Re: Contract No. 200-2004-03805, Task Order 1: Draft Review of the
NIOSH Site Profile for the Y-12 National Security Complex

Y-12 National Security Complex Site Profile Review

Contract No. 200-2004-03805
Task Order No. 1
SCA-TR-TASK1-0007

Figure 1: ORAUT-RPRT-0032 (Kerr 2005a) Attachment 1, Page 136

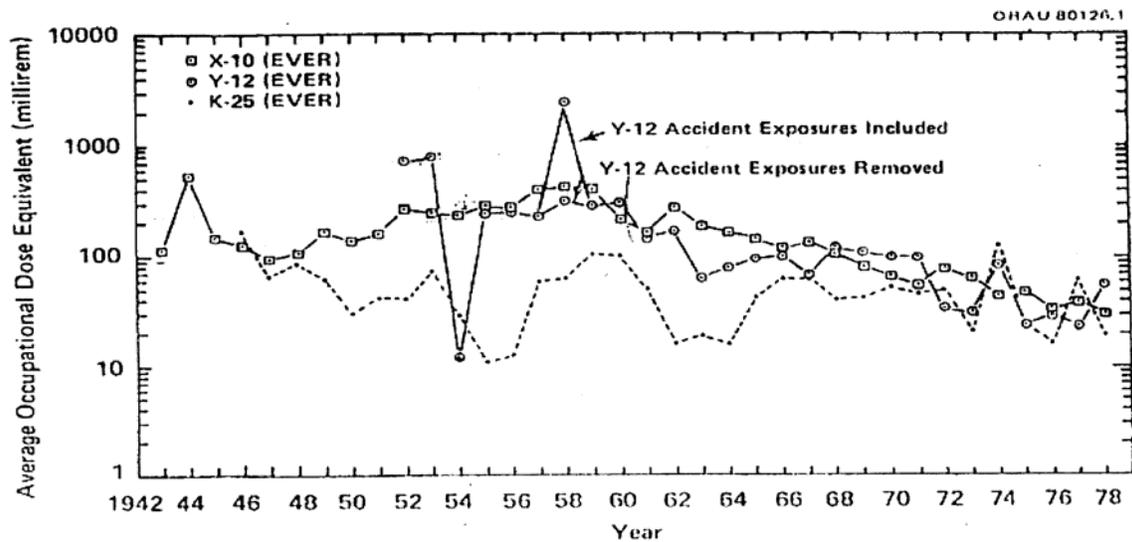
While the potential for external radiation doses may not have been as large as at some other AEC/DOE facilities, the potential for radiation exposure was not negligible at Y-12. For example, ORAUT-RPRT-0032 (Kerr 2005a) and ORAUT-RPRT-0033 (Kerr 2005b) give a more complete picture of the radiation fields present at Y-12 through the years. ORAUT-RPRT-0032 (Kerr 2005a, pg. 136) shows a plot of average annual dose versus year from 1952–1978; the average was around 170 mrem/year.

Figure 2: Statistical Measures by Quarter from Table 1 of ORAUT-OTIB-0013
($m = \mu$, $s = \sigma$)

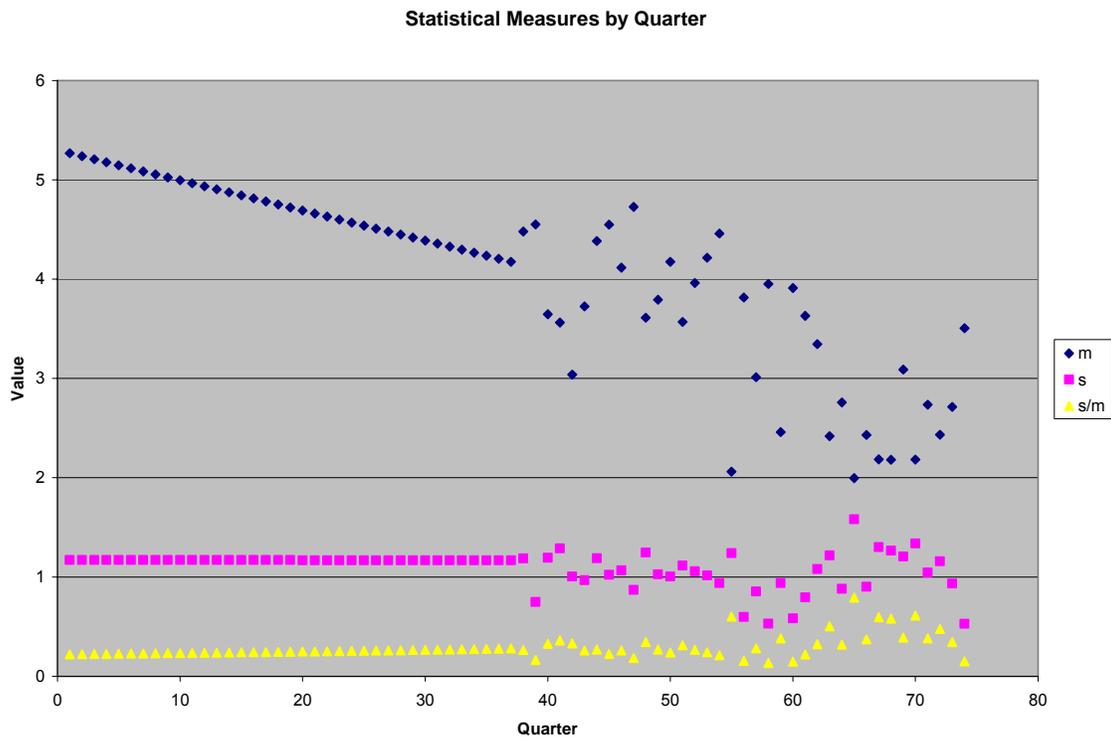
First, the statistical measures shown in Table 1 of OTIB-0013 (Frome and Groer 2004) (μ and σ) are treated as true measures of the characteristics of the underlying lognormal distribution, rather than estimates. It is instructive to plot these data by quarter. This is shown in Figure 2 below.

For both μ and σ , we have two distinct periods. The first runs from quarter 1 to quarter 37 (which is the third quarter of 1956). Over this period, there is a smooth and continuous trend in both quantities. This is because the estimates come from a regression analysis on 147 workers with dose measurements over the period. The second period occurs subsequently. In this case, results are estimated from observations on a quarter-by-quarter basis, and the data exhibit considerable scatter. This scatter could be due to two effects; these are actual variations in workplace conditions from quarter to quarter and the limited size of the database. The second of these should be less important, as most relevant workers should be included, so we are not in the situation of extrapolating from a small sample to a much larger population. We, therefore, take the view that this variation is due to changes in workplace conditions. At a population level, a similar degree of variability should exist before the third quarter of 1956. Therefore, the values of μ and σ used for quarters before the third quarter of 1956 are estimates and not the true values.

Figure 3: Annual Film Badge Monitoring of Y-12 Workers for Gamma Exposure (Watkins 2004)

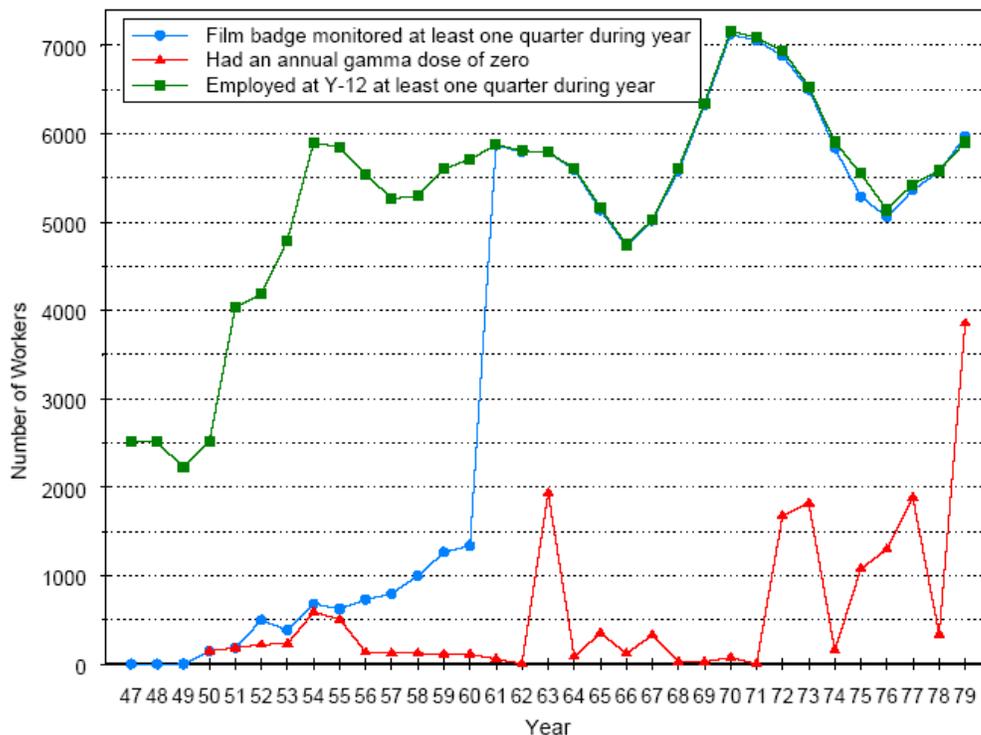
Our concern is that there is no reason to assume that the dose received by an individual differs from the population dose by a constant factor. Over the period of interest, the size of the population changed markedly. Figure 3, recreated from ORAUT-OTIB-0013 (Frome and Groer 2004), which is taken from Watkins et al. (2004), illustrates this point.

Note the trends both in total numbers of workers and in those monitored through to 1960. Note also the jump to complete monitoring of the workforce after 1961. A worker performing a specific job with his own particular trend in dose is being compared with a population, which exhibits an overall trend in dose, because various individual jobs within that population exhibit trends in dose and because the mix of jobs being undertaken will change. In particular, the change in monitoring philosophy in 1960 will have brought a large number of jobs into monitoring that were not previously represented in the population. In this context, it is of interest to note that the first quarter of 1961 is quarter 55 in Figure 2 above. Careful examination of that figure suggests an alternative interpretation; with μ having a typical value of around 4.0 between quarter 38 and quarter 55, and then jumping down to a lower value of around 3.0 from quarter 56. From these considerations, it is evident that the analysis makes two jumps of logic:

- It assumes that the difference between an individual's dose and the population dose from 1961 to 1965 can be used to infer the difference between that individual's dose and the population dose in the earlier period, even though there was a complete change in monitoring philosophy and consequently in the size and variety of work experience of the monitored population;
- It assumes that the time trend in individual exposure mirrors the typical time trend in overall population exposure.

The fallacy of the latter can be readily appreciated by considering an individual who worked unmonitored in a relatively high-exposure task in the late 1950s and was then moved to a low-exposure task in 1960. In 1961, he would have been monitored because of the change in philosophy. In this case, his post-1961 exposure might be lower than the population average, but his pre-1961 exposure might be higher than the average.

Figure 4: One-Year Committed Dose in Sv per Bq Excreted in After Weekend Urine Samples after One Year of Work

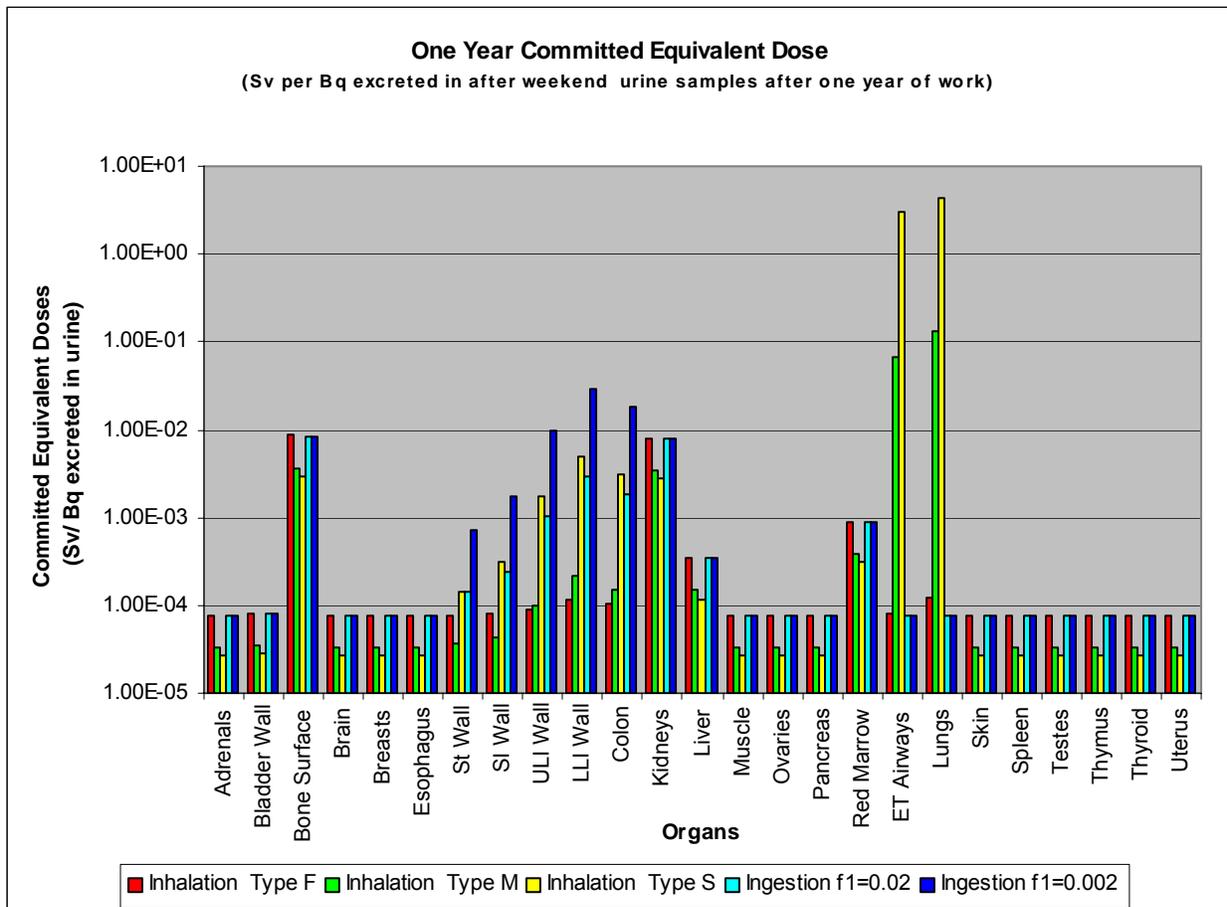
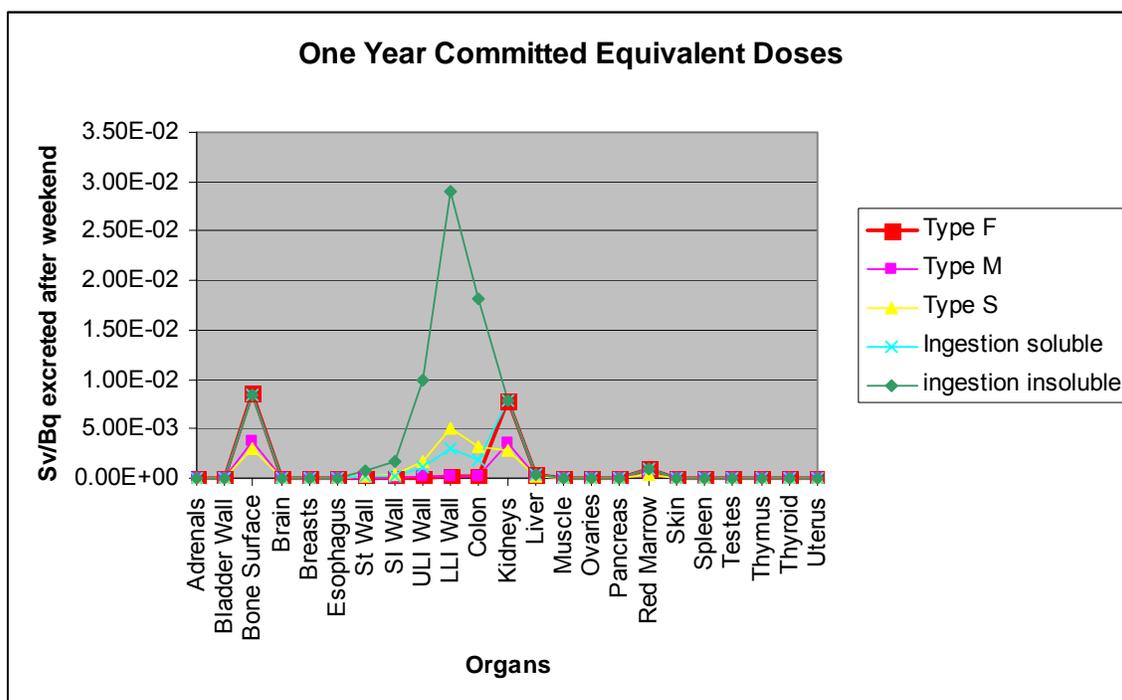
As can be seen from Table 1, doses coming from the ingestion pathway should not be ignored, especially in the case of cancer to the gastrointestinal (GI) tract. Figures 4 and 5 graphically represent the information provided in Table 1.

SC&A recommends that ingestion of uranium compounds be included as a part of the internal dose for GI tract.

Figure 6: One-Year Committed Equivalent Dose for All Organs

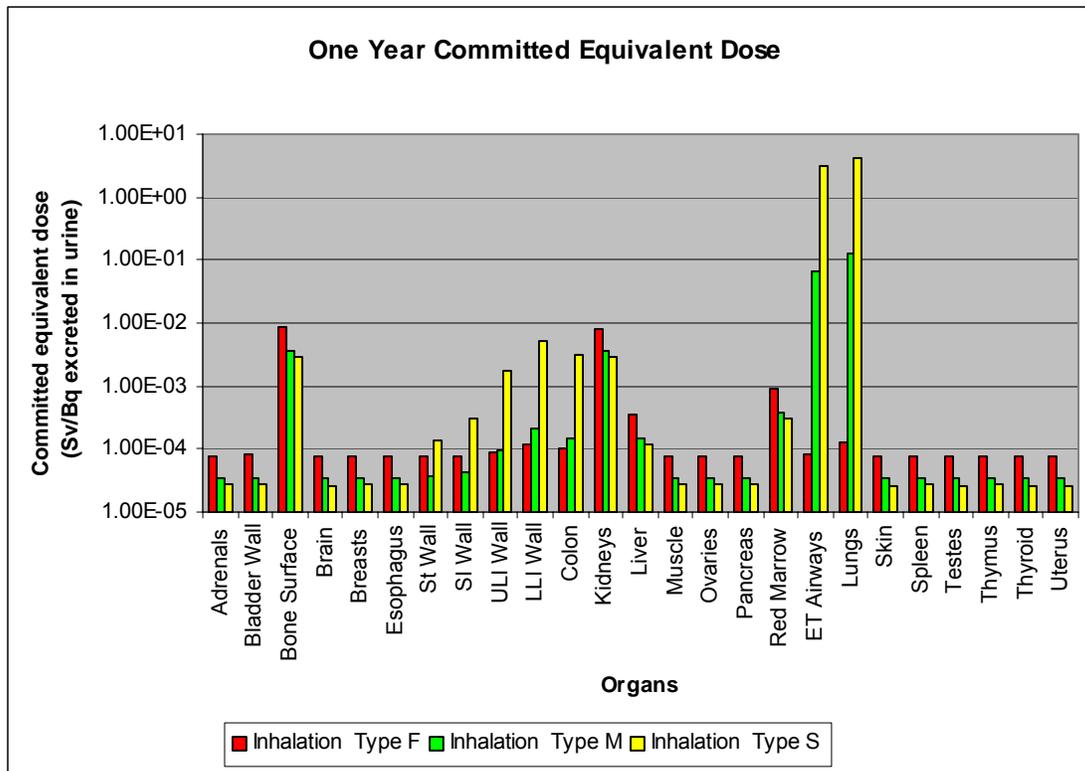
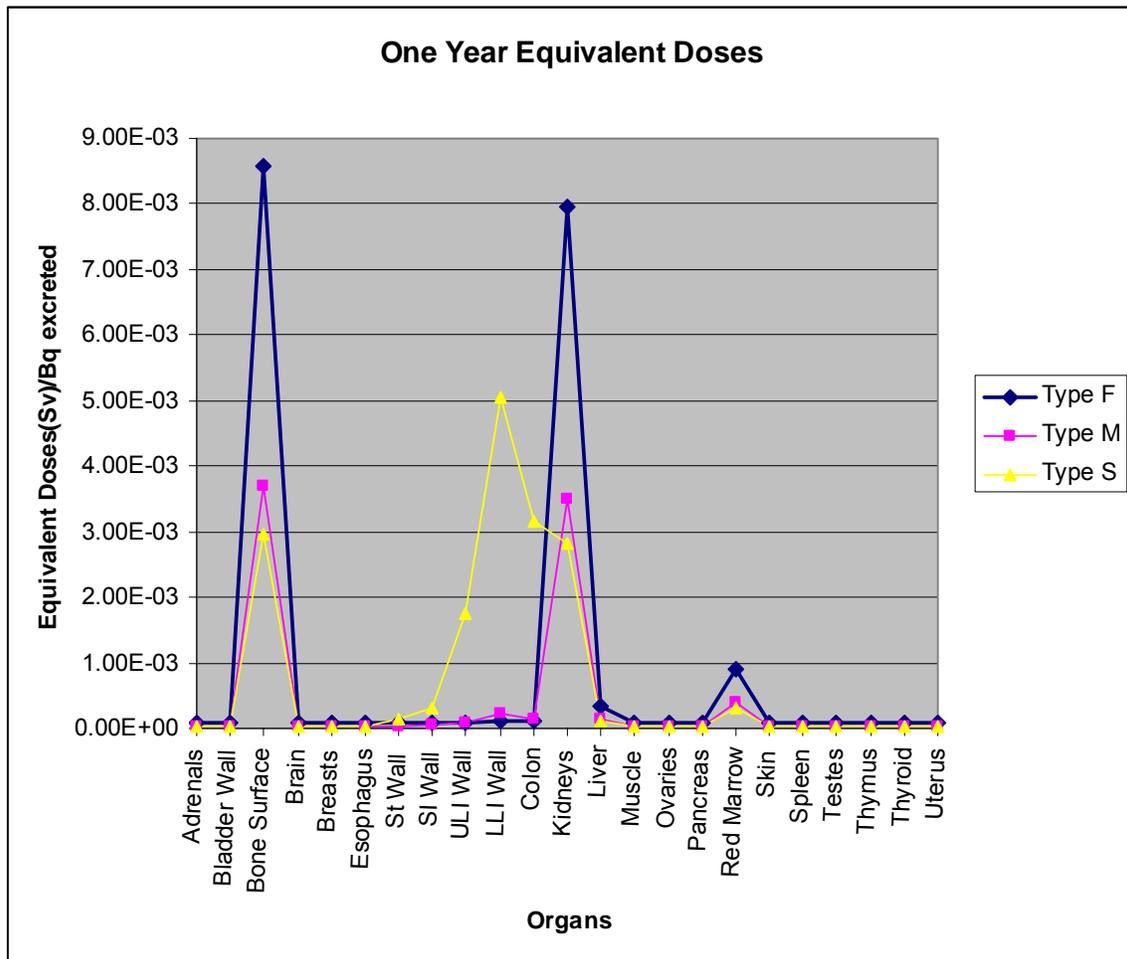
SC&A finds the assumption that doses should be assigned based on exposures to uranium compounds of solubility Types M and S, without considering Type F compounds, not claimant favorable, for many cancer sites. This assumption does not follow instructions given in 42 CFR Part 82, which specifically states the following:

Figure 8: One-Year Committed Equivalent Doses from Ingestion of Insoluble Compounds

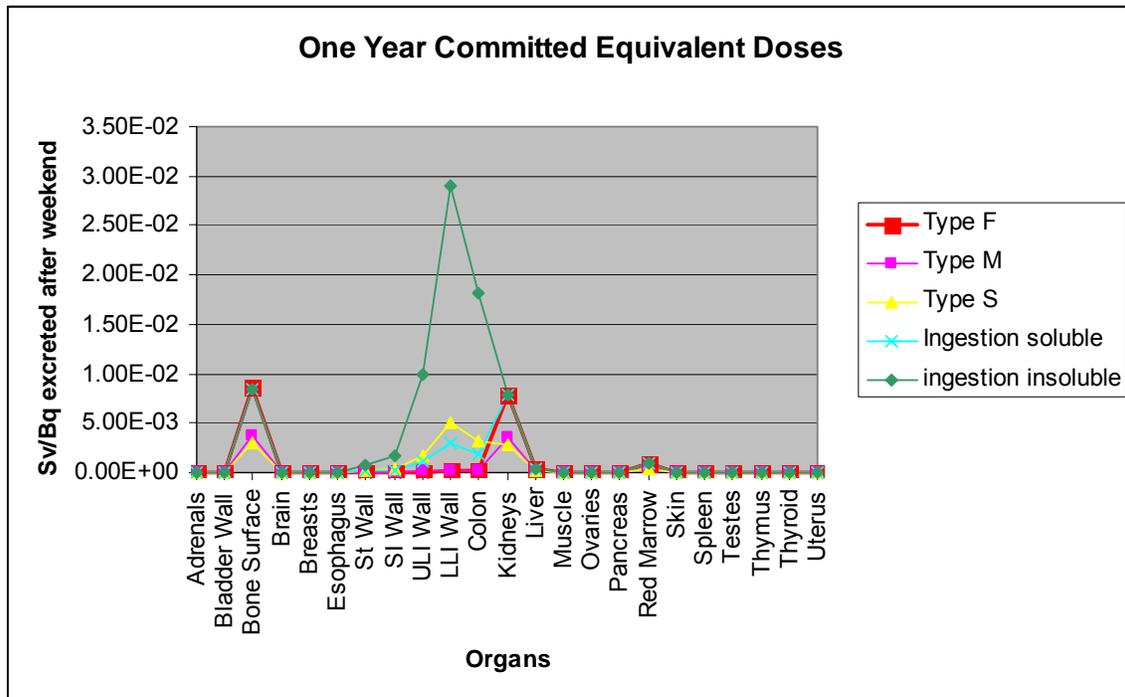
The ingestion pathway of exposure was not considered in the derivation of co-worker data. The amount of uranium that enters through ingestion is very important in terms of interpretation of bioassay results and conversion to organ equivalent doses per Bq excreted. The use of bioassay results to back-calculate intake and doses will produce higher doses for certain organs, if the ingestion pathway of exposure is used, instead of the inhalation pathway. As seen in Figure 8, ingestion of insoluble compounds results in doses to the GI tract that are higher than if inhalation

was assumed. SC&A finds that it is not claimant favorable to ignore the ingestion pathway of internal contamination. The ingestion of insoluble compounds should be included as a part of the internal dose in cases of GI tract cancers.

Figure 9: Energy Response of a Typical Survey Meter with a 1-inch NaI Crystal (Ludlum 2000)

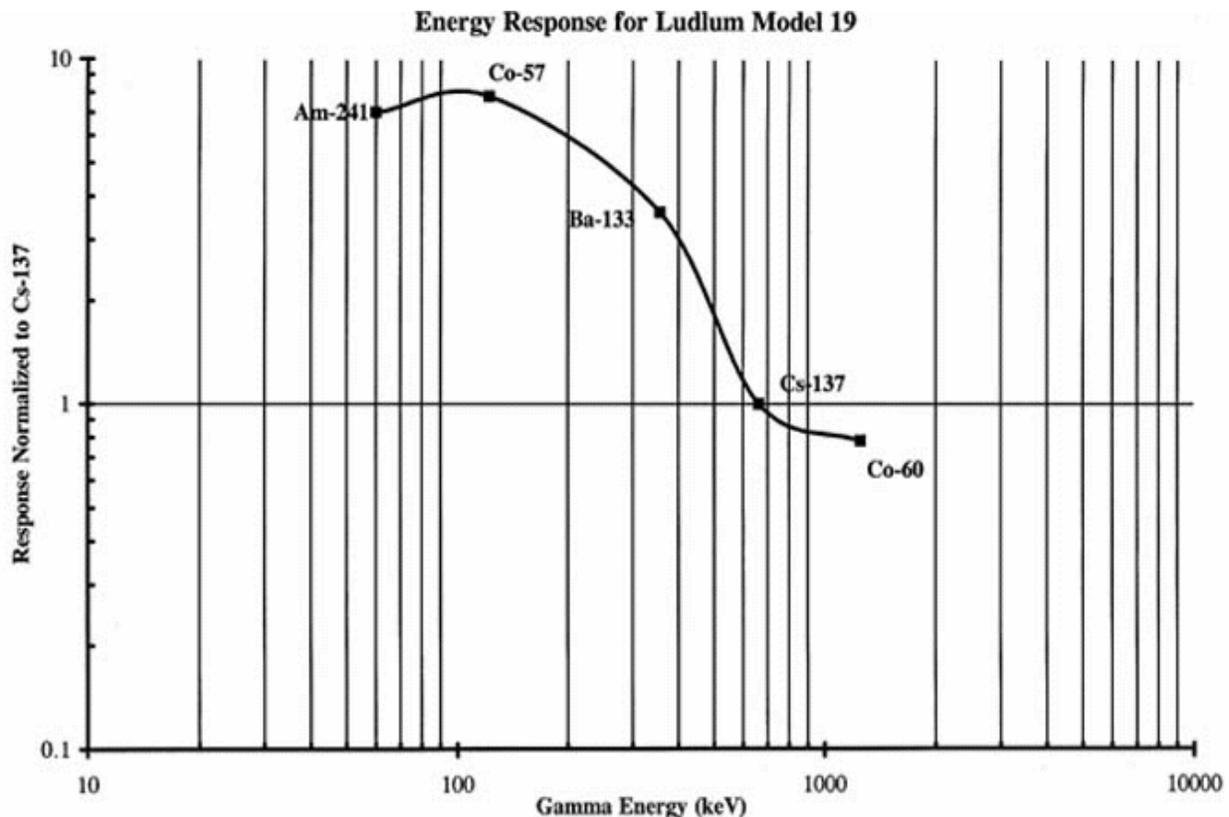
We have questions about the methods used to convert the results of the scoping survey into dose rates. Given the purpose of the survey and the instruments used, we believe that the exposure rates were based on the count rates registered by the sodium iodide crystal in the survey meter. Such meters are commonly calibrated with a ¹³⁷Cs source—the scale on the rate meter is set to the calculated exposure rate at the location of the detector. This calibration is thus valid only for the principal ¹³⁷Cs (γ-ray and will vary significantly with photons of different energies. The meter readings should be converted to dose rates in air (i.e., air kerma) using calibration curves, which can be obtained from the manufacturer of the meter in question or from manufacturers of similar instruments, and the known spectrum of the uranium isotopes deposited on the ground. (See the response curve for a 1" x 1" NaI crystal provided in Figure 9). The aerial survey data, which includes some spectral analysis, would be useful in this regard. The air kerma, in turn, should be converted to dose equivalent rates, using tables in ICRP Publication 74 (ICRP 1996) for the appropriate exposure geometry.
